**Notice of Allowability**

10/716,990

KOMMA ET AL.

Inventor: KOMMA et al.  
Docket No.: 10873.1356US01  
Title: OPTICAL ELEMENT, OPTICAL LENS, OPTICAL HEAD APPARATUS, OPTICAL INFORMATION APPARATUS, COMPUTER, OPTICAL INFORMATION MEDIUM PLAYER, CAR NAVIGATION SYSTEM, OPTICAL INFORMATION MEDIUM RECORDER, AND OPTICAL INFORMATION MEDIUM SERVER  
Attorney Name: Douglas P. Mueller  
Phone No.: 612.455.3800  
Sheet 1 of 19  
REPLACEMENT SHEET

FIG. 2

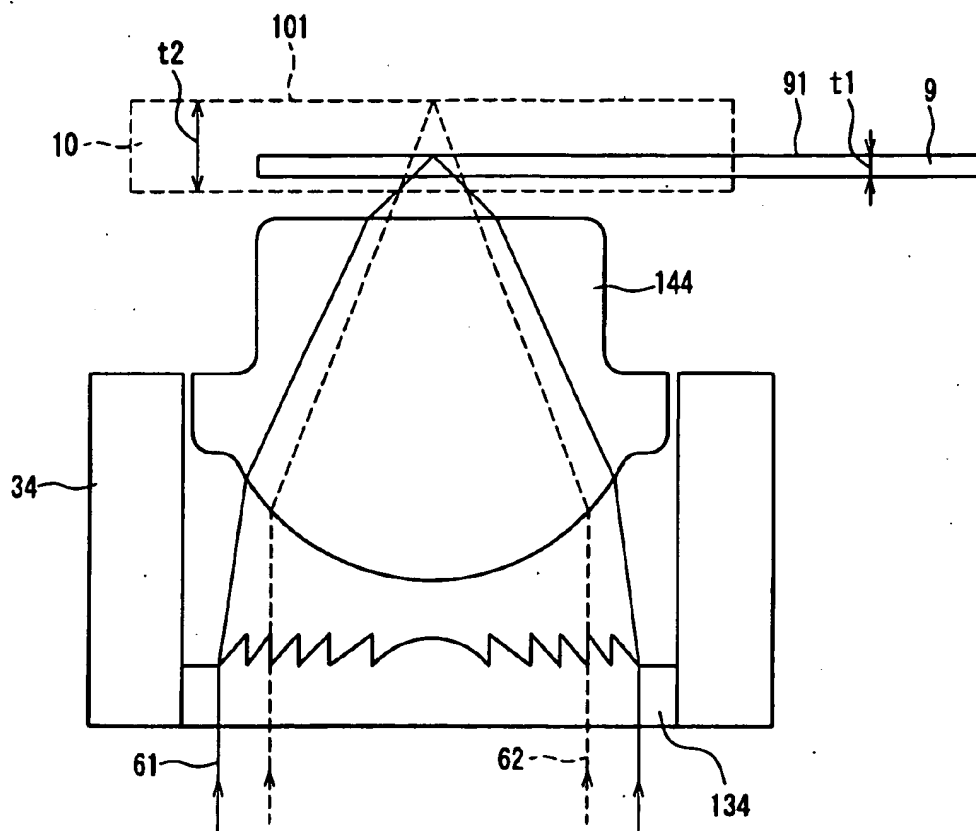
3. The replacement drawings were received on 10/31/06. These drawings are objected to for the following reason(s) as set forth below.
4. The drawings are objected to as failing to comply with 37 CFR 1.84(p)(5) because they include the following reference character(s) not mentioned in the description: Figures 2, 5, 7, 10, 13, 14- Reference numeral 34 (not all instances of '34' were removed in the replacement drawings submitted 10/31/06).

Corrected drawing sheets in compliance with 37 CFR 1.121(d), or amendment to the specification to add the reference character(s) in the description in compliance with 37 CFR 1.121(b) are required in reply to the Office action to avoid abandonment of the application. Any amended replacement drawing sheet should include all of the figures appearing on the immediate prior version of the sheet, even if only one figure is being amended. Each drawing sheet submitted after the filing date of an application must be labeled in the top margin as either "Replacement Sheet" or "New Sheet" pursuant to 37 CFR 1.121(d). If the changes are not accepted by the examiner, the applicant will be notified and informed of any required corrective action in the next Office action. The objection to the drawings will not be held in abeyance.
